for Slide Brake, Spindle Purge or Collet Closer Lube

MAC Single Solenoid kit to replace Festo
p/n 997-09-002

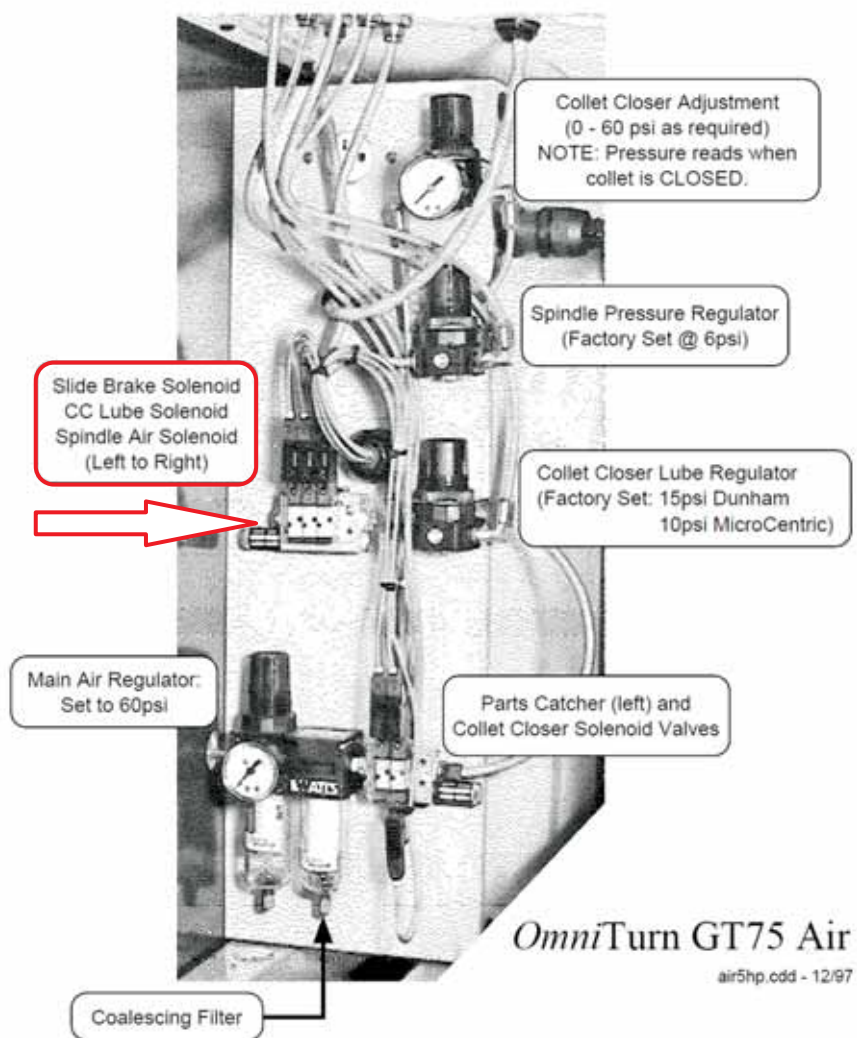
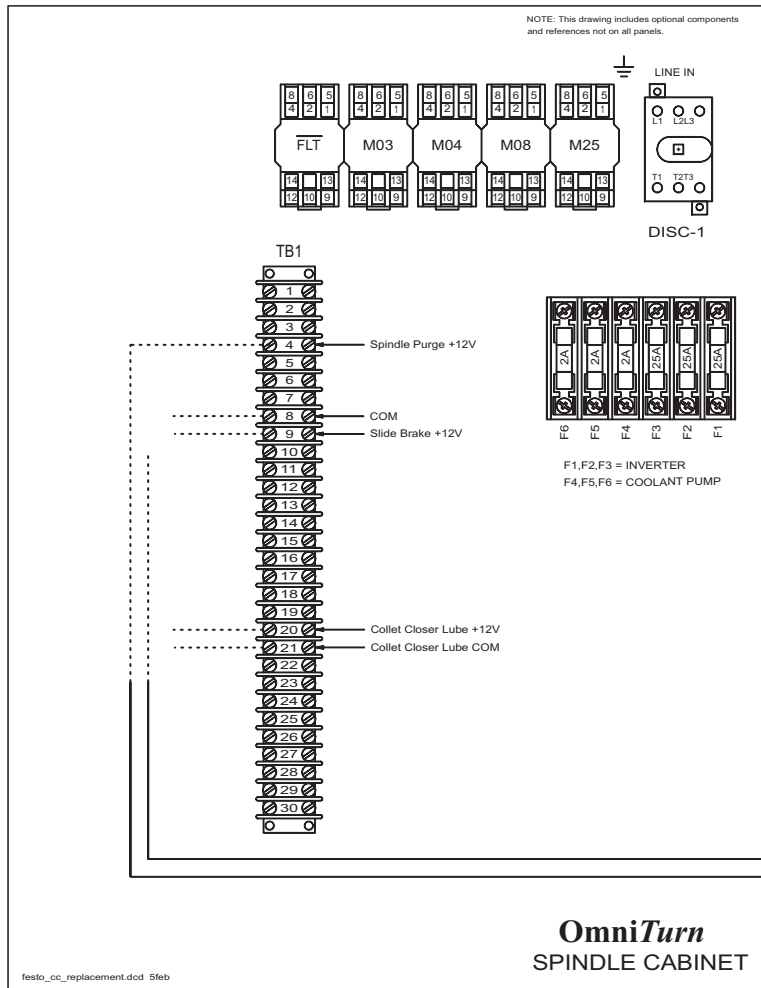
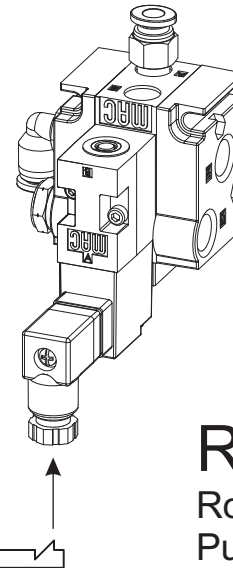
Replace old solenoid cables with new
 If replacing Spindle Purge, route cable to TB1-4 & TB1-8
 If replacing Slide Brake, route cable to TB1-8 & TB1-9
 If replacing Collet Closer Lube, route cable to TB1-20 & TB1-21

Route air as appropriate for Spindle Purge, Slide Brake, or Collet Closer Lube function.

Mount MAC valve wherever convenient using 6-32 screws provided.
